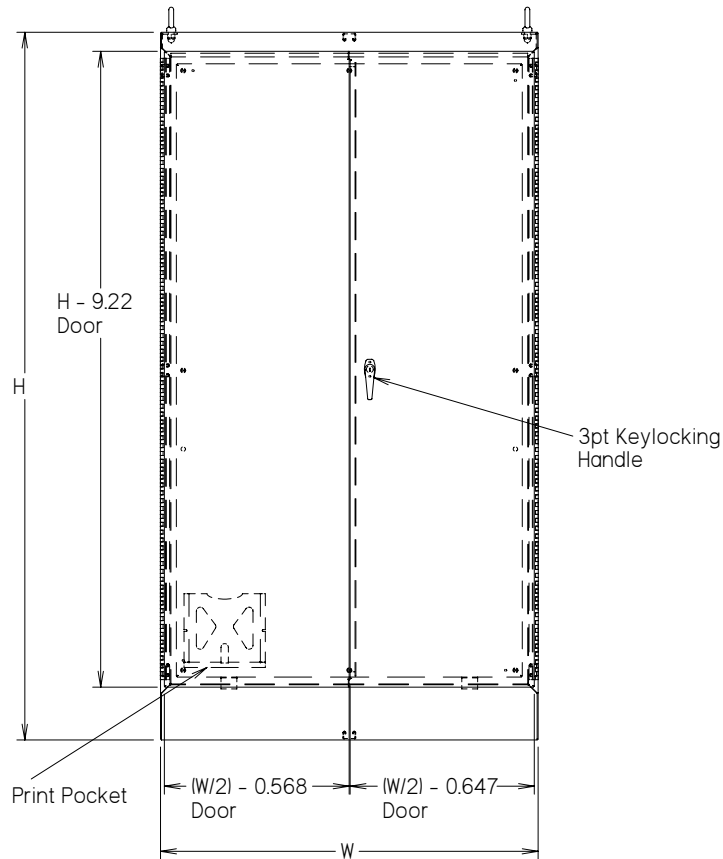
Doors Removed

Enclosure will only receive 4 lifting eyes
if D is less 24" or more
